CASE NO. SP2020-007

RE: REVISION NARRATIVE – AMENDED SITE PLAN SUBMITTAL

The following changes have been made to the previous approved site plan.

SPR PACKAGING
 OFFICE ADDITION
 1480 JUSTIN RD., ROCKWALL, TEXAS

IRRIGATION PLAN

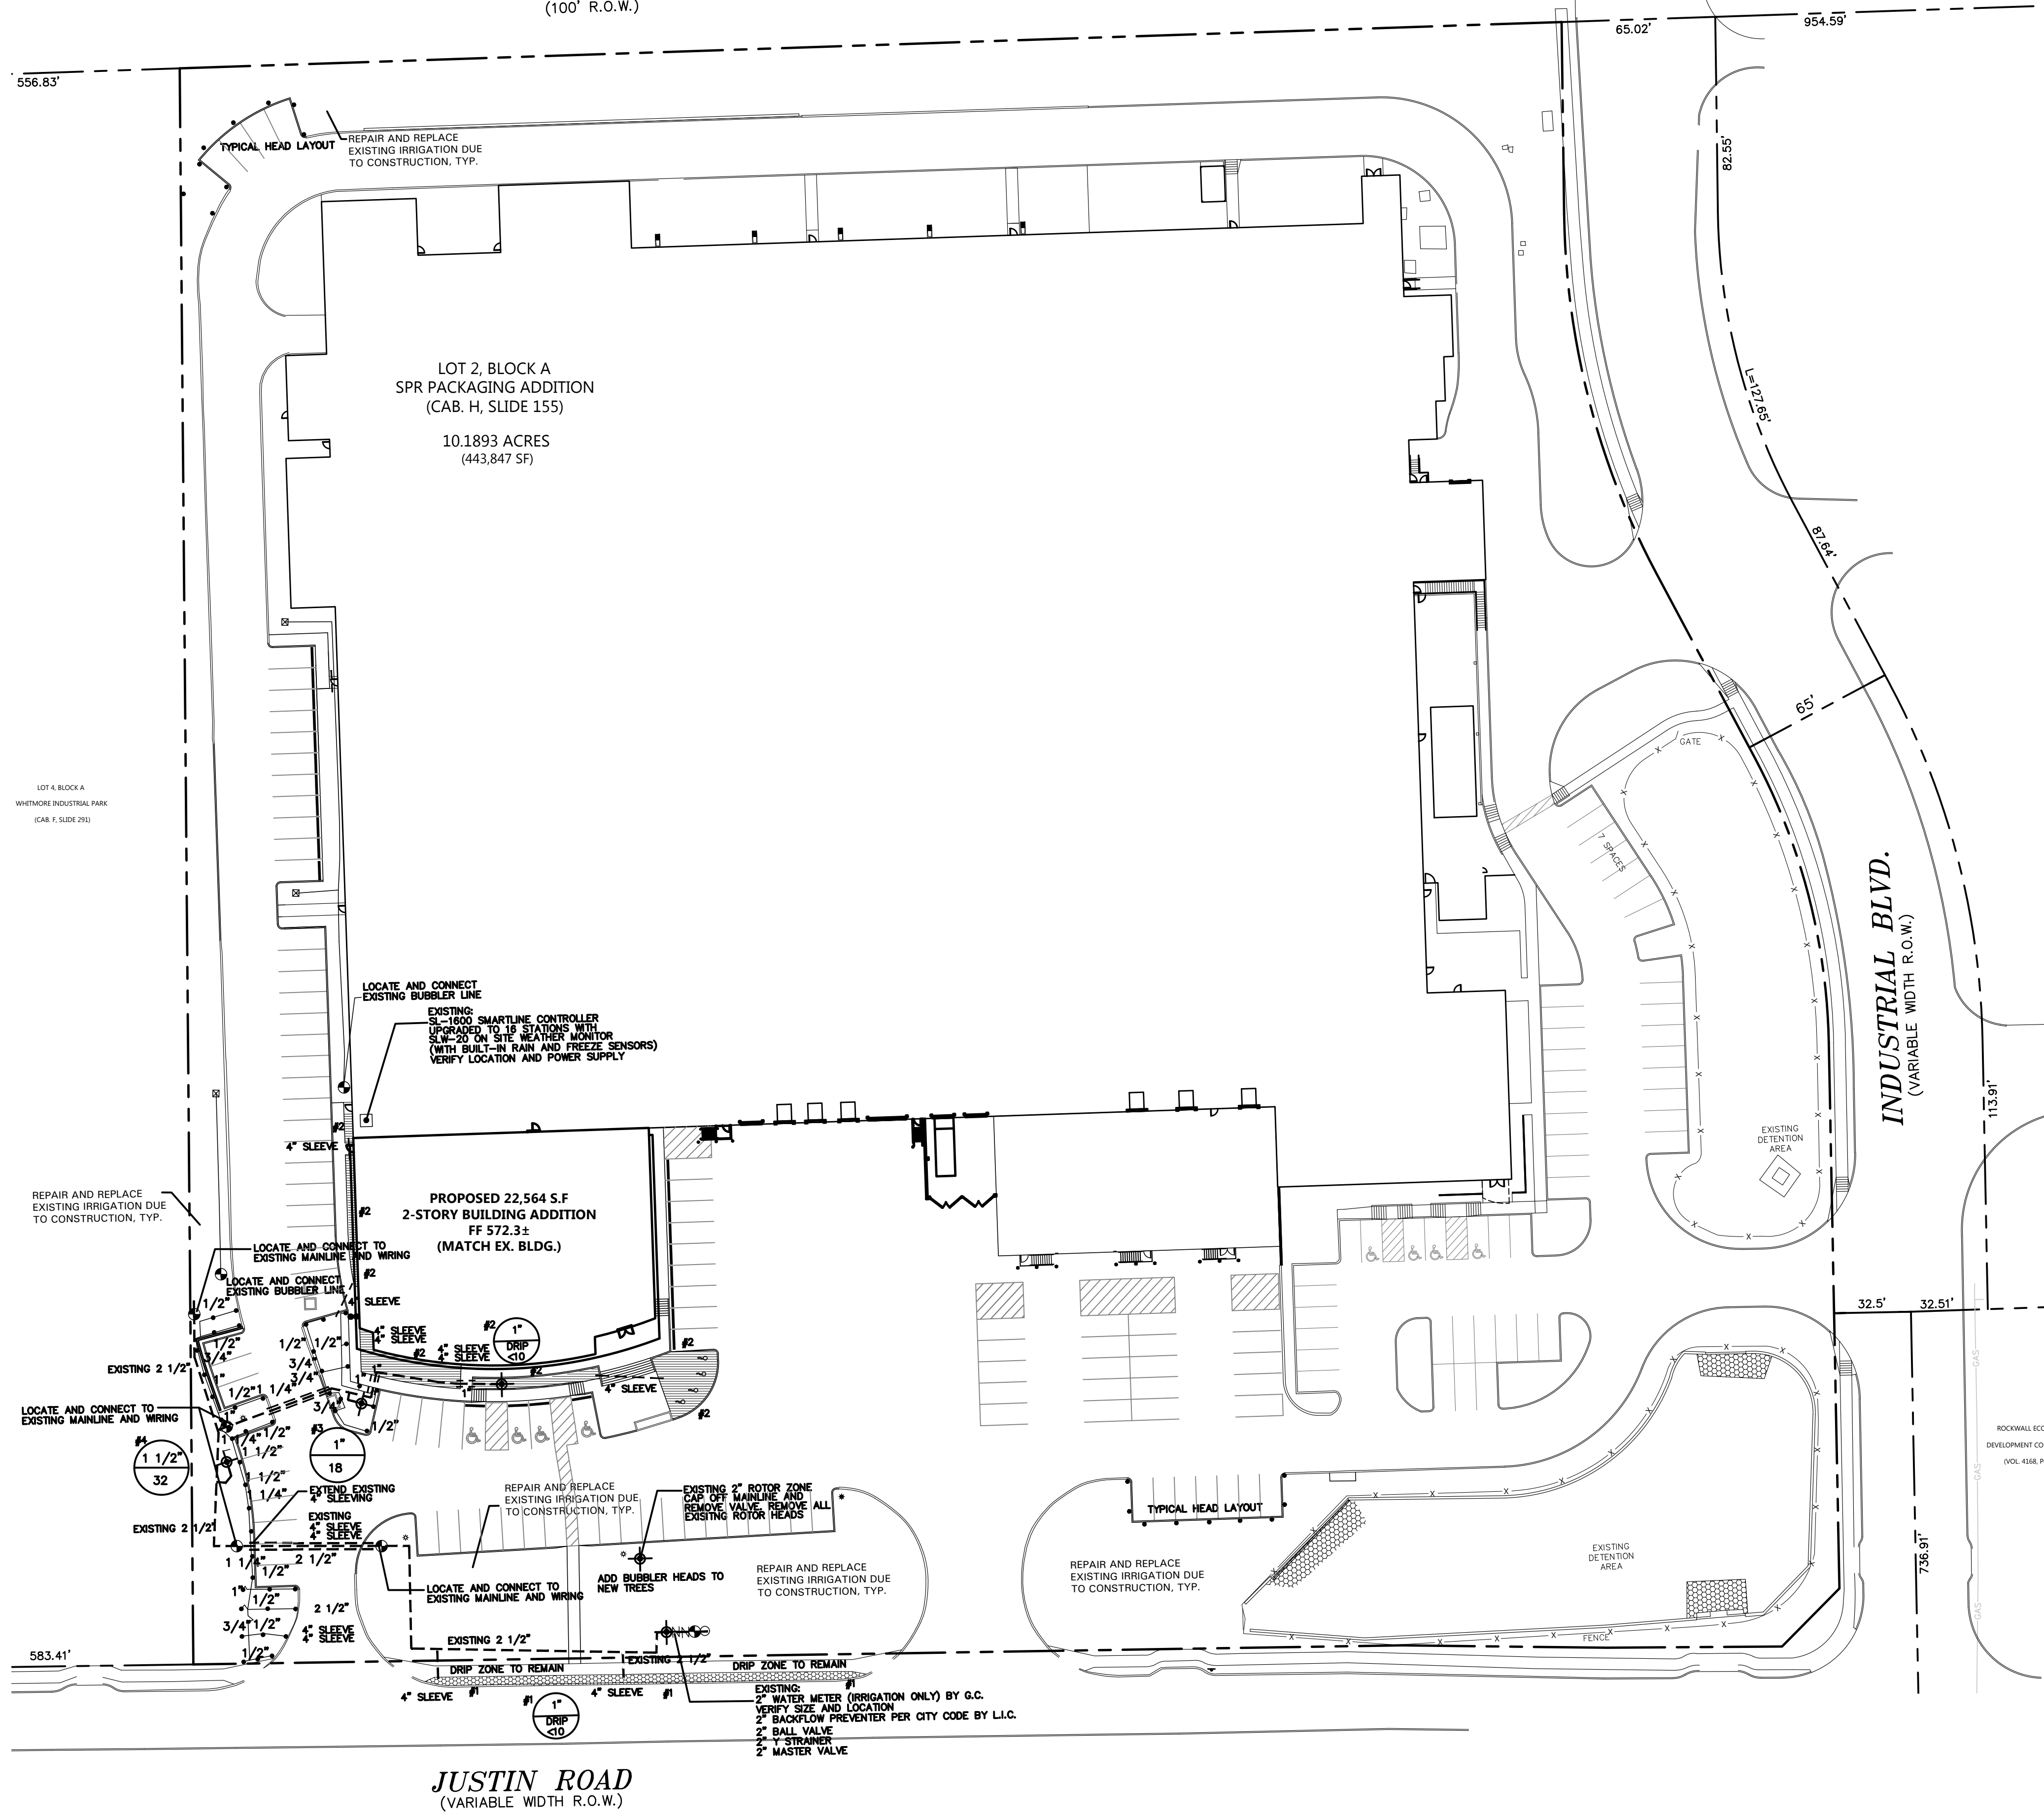
- Revised irrigation design along the new parking configuration and affected drive areas.
